PLAN COMMISSION REPORT

Proposal: Planned Unit Development Amendment (Conditions and Restrictions)

Description: Review setback modification and lot split requests as part of the Planned Unit Development and Conditions and Restrictions at Oaks at 8100.

The Oaks at 8100

**EXHIBIT A:
MODIFIED CERTIFIED SURVEY MAP/LOT SPLIT**

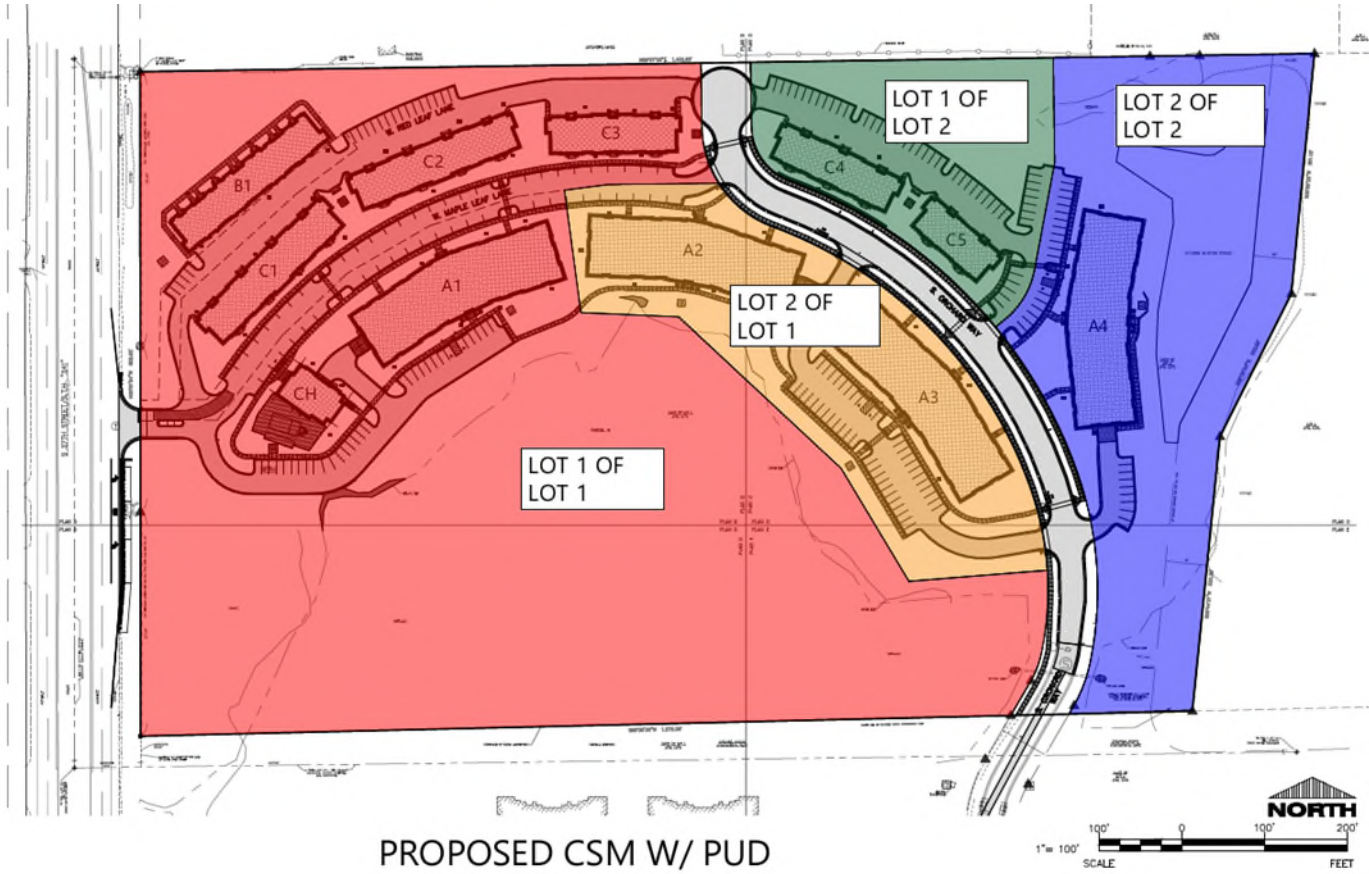
The request is to split Lot 1 of CSM 9404 into Lot 1 and Lot 2, and Lot 2 of CSM 9404 into Lot 1 and Lot 2. Building A2 and A3 are proposed to be located on the new Lot 2 of Lot 1 of CSM 9404 and A4 is proposed to be located on Lot 2 of Lot 2 of CSM 9404. There are no changes to the recorded S. Orchard Way ROW. Reference the preliminary CSM submitted with the PUD request. As part of the lot split, side parking setbacks are requested to be approved/amended with the amendment to the PUD and change from 5' to 0' all related to the common property line between the new lines. Again, the design and improvements of the approved PUD have and will not change.

The following section 7 of the Conditions and Restrictions approved in Ordinance 3015 is amended as set forth below:

Front and Public ROW Setback	Rear Setback	Side Setback
Building A2*	16 ft	25 ft	10 ft
Building A3*	12 ft	25 ft	10 ft
Building A4*	18 ft	25 ft	10 ft
Building C3*	25 ft	25 ft	10 ft
Building C4*	10 ft	25 ft	10 ft
Building C5*	14 ft	25 ft	10 ft
All Other Principal Structures*	30 ft	25 ft	10 ft
Accessory Structure**	30 ft	10 ft	5 ft
Off-street Parking	5 ft	5 ft	0 ft

PROPOSED CSM W/ PUD

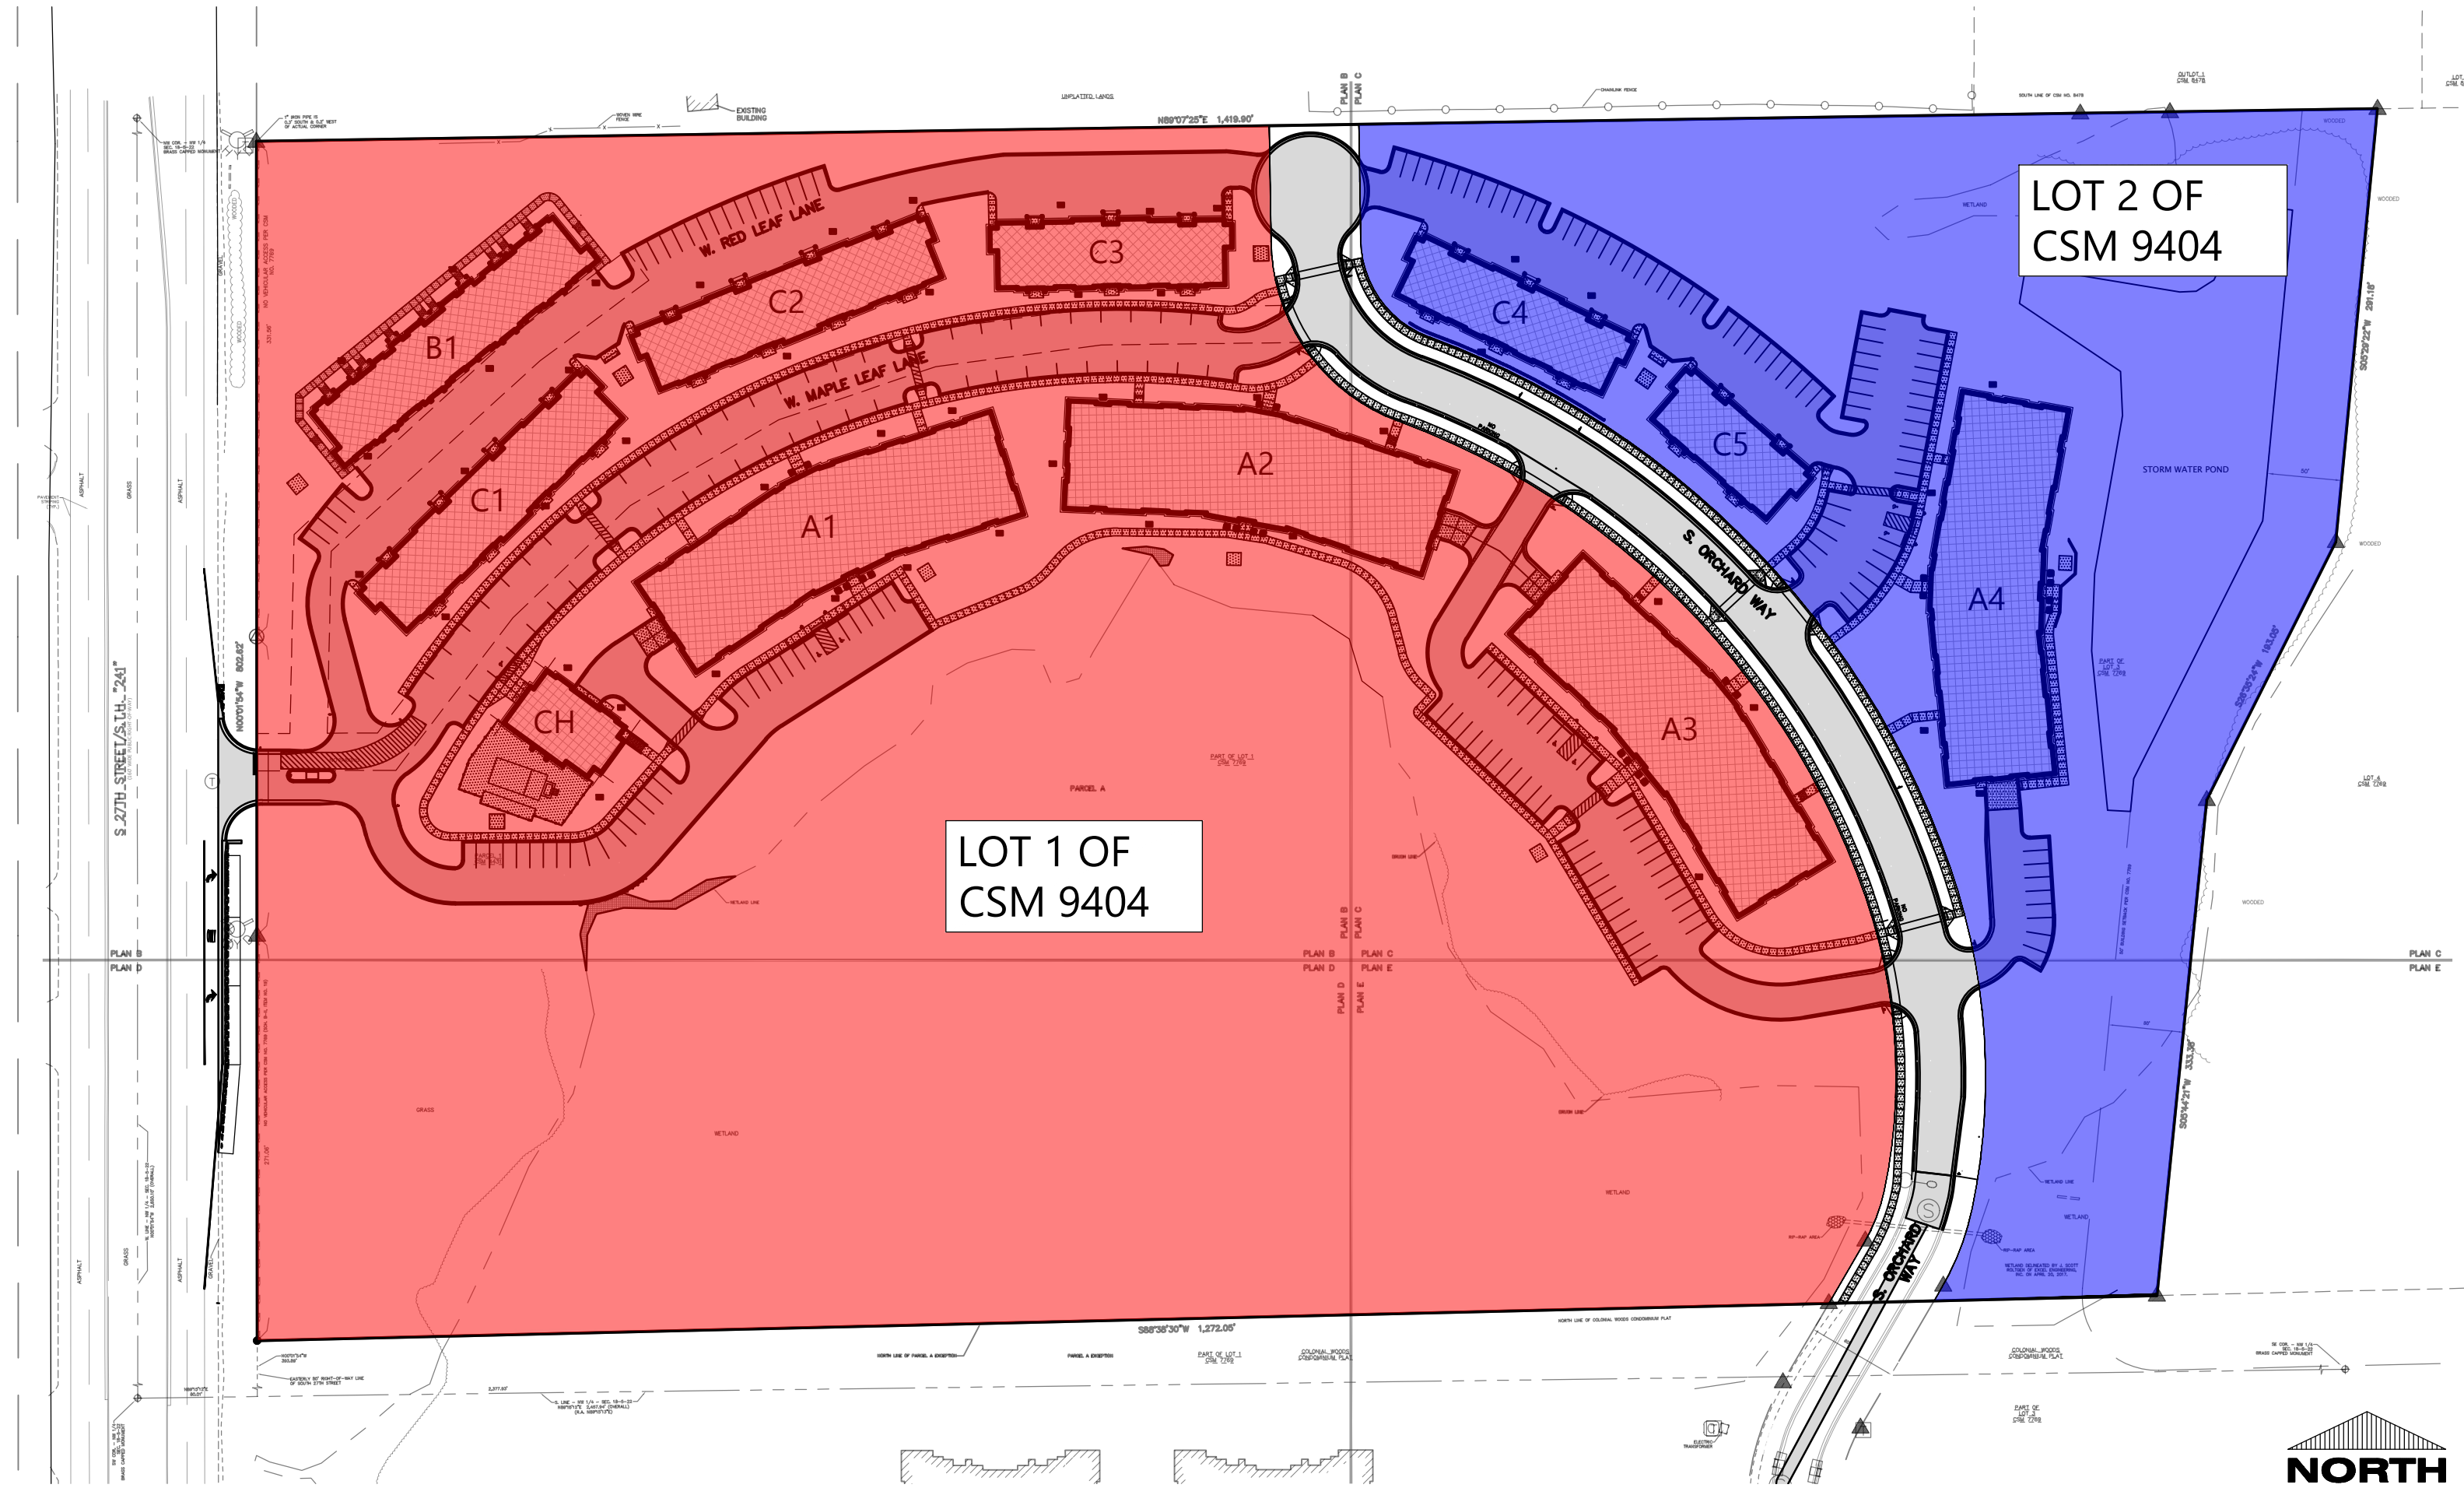
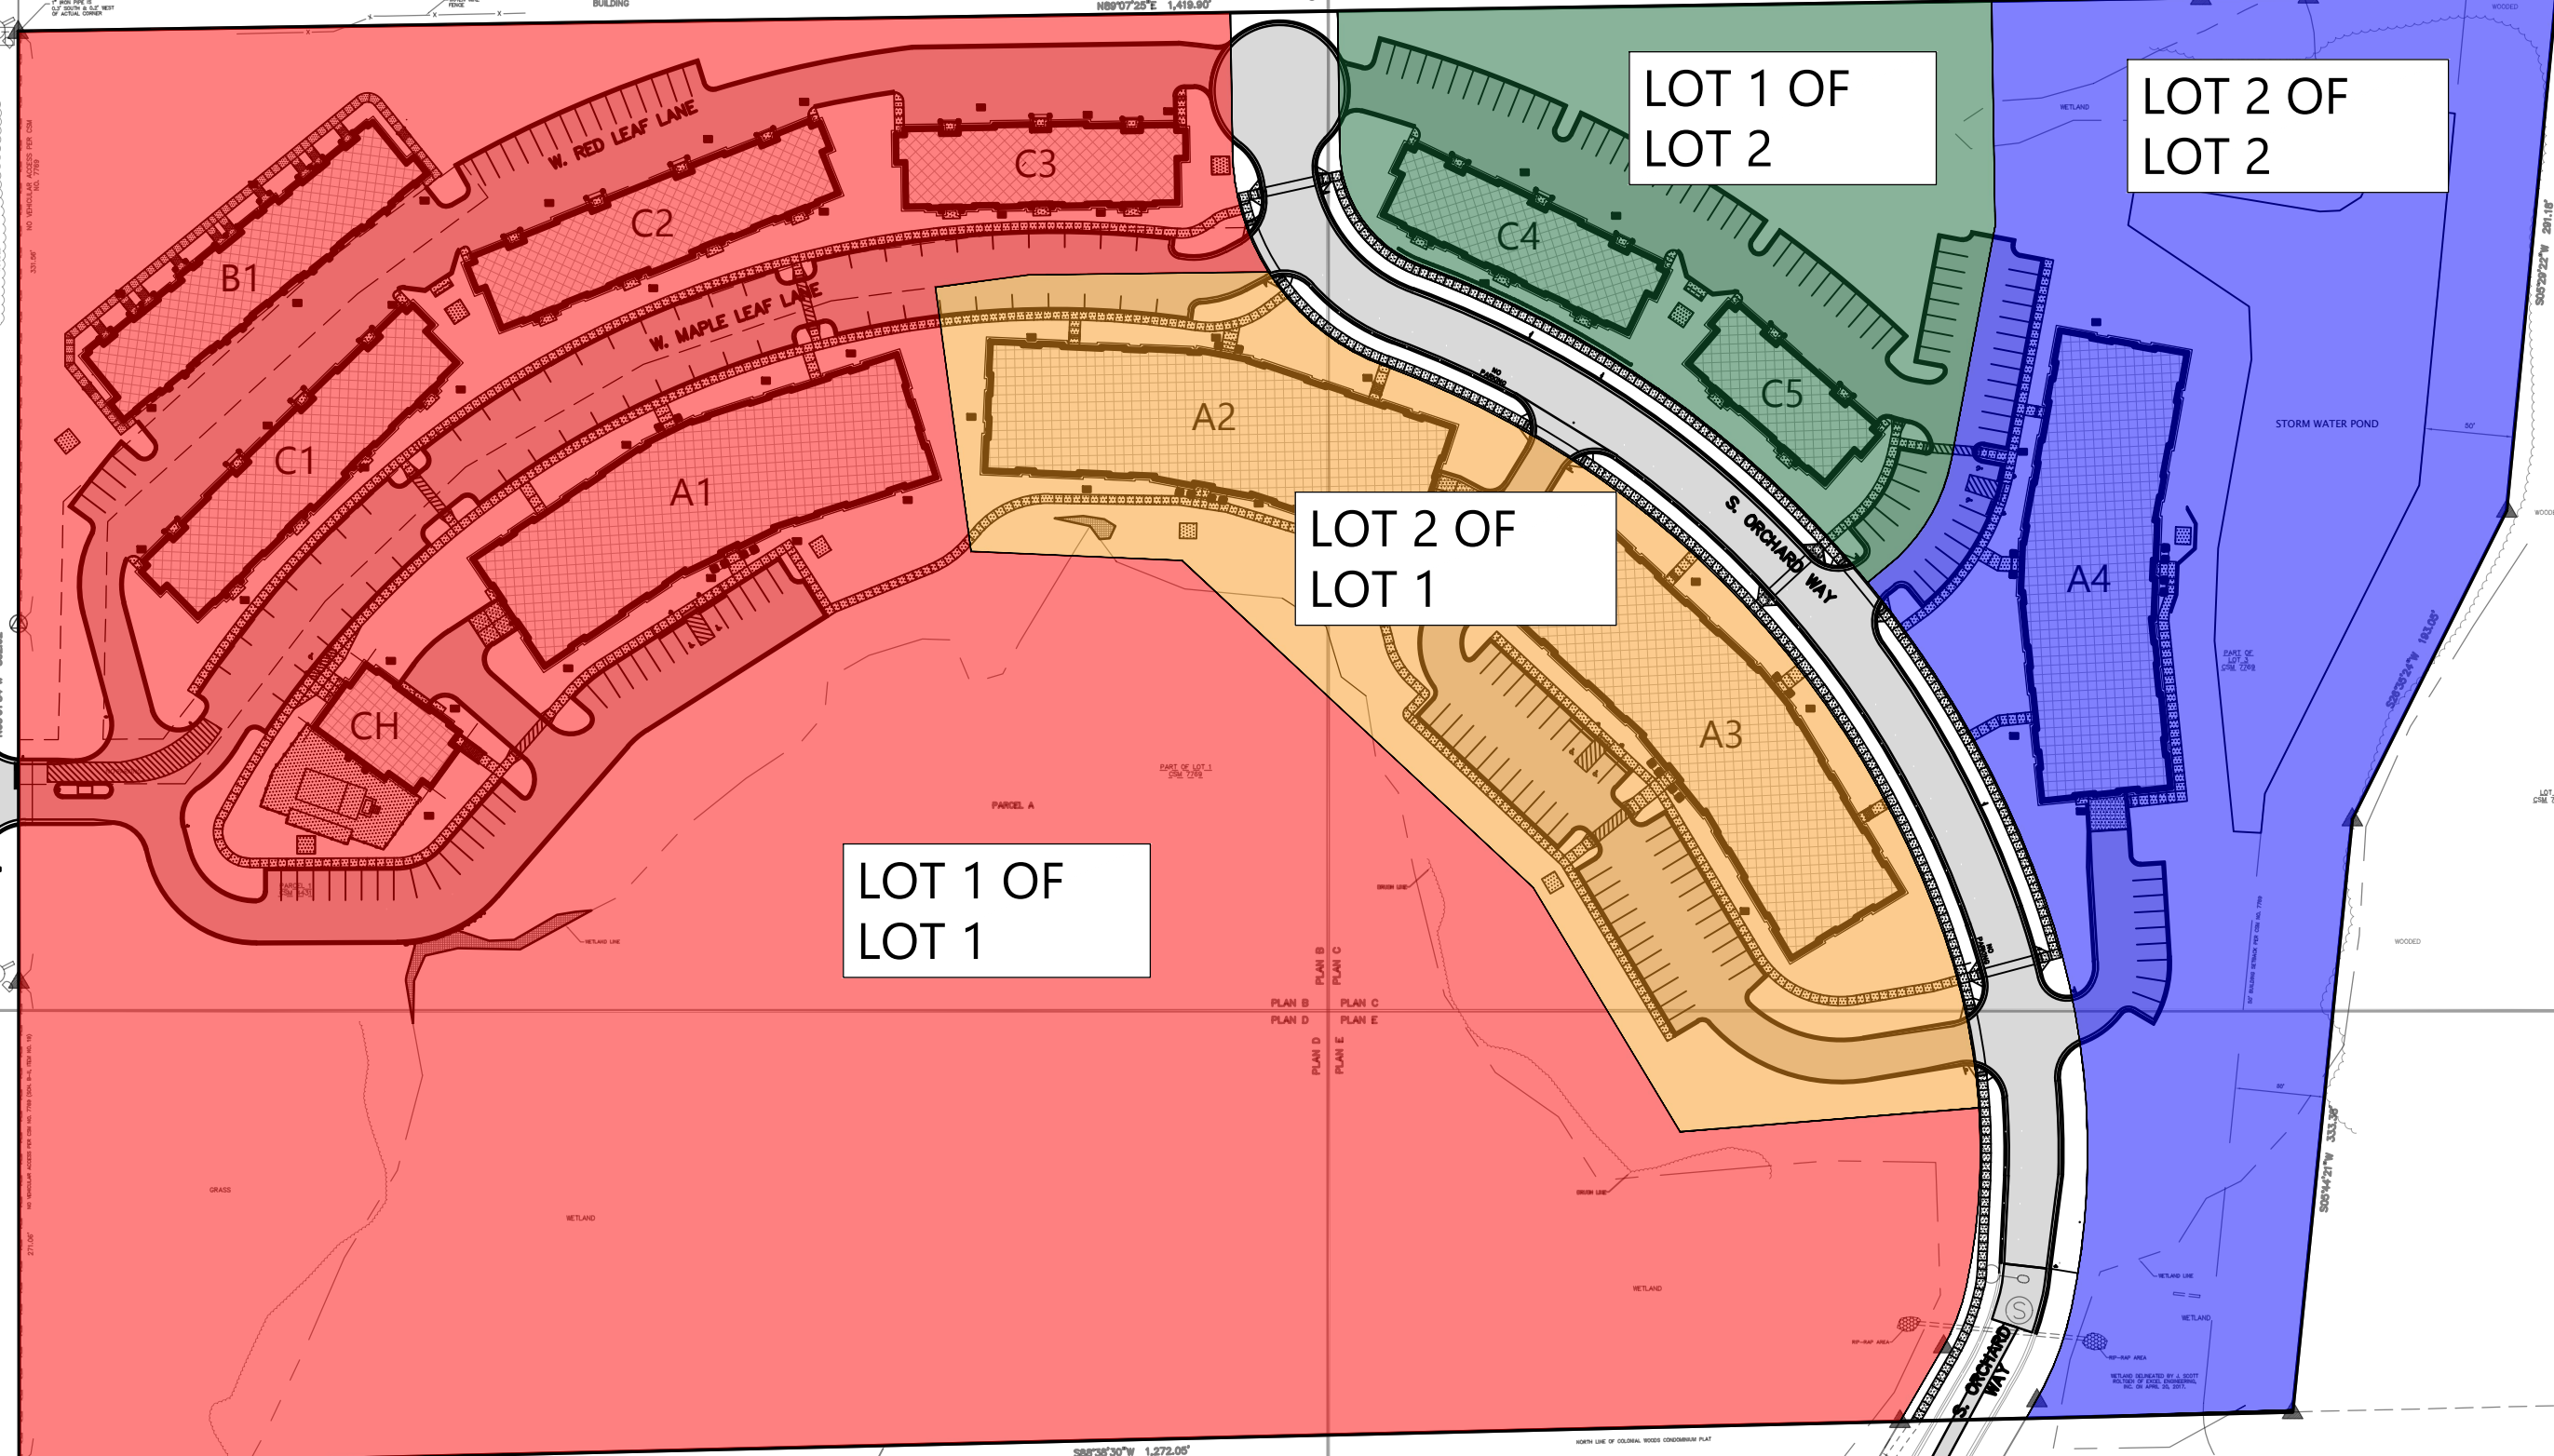
The Oaks at 8100 project was divided into two (2) pieces of land, Lot 1 of CSM 9404 and Lot 2 of CSM 9404, split by S. Orchard Way right-of-way. Today’s proposal is to split Lot 1 of CSM 9404 into two (2) parcels (Lot 1 and Lot 2), and to split Lot 2 of CSM 9404 into two (2) parcels (Lot 1 and Lot 2). There are colored attachments that show the “as-is” situation, and the proposed lot split.

- i. New Lot 1: 628,747 sf (14.434 acres)
- ii. New Lot 2: 121,662 sf (2.793 acres)
- b. Lot 2 of CSM 9404: 262,357 sf (6.023 acres)**
 - i. New Lot 1: 78,436 sf (1.801 acres)
 - ii. New Lot 2: 183,921 sf (4.222 acres)
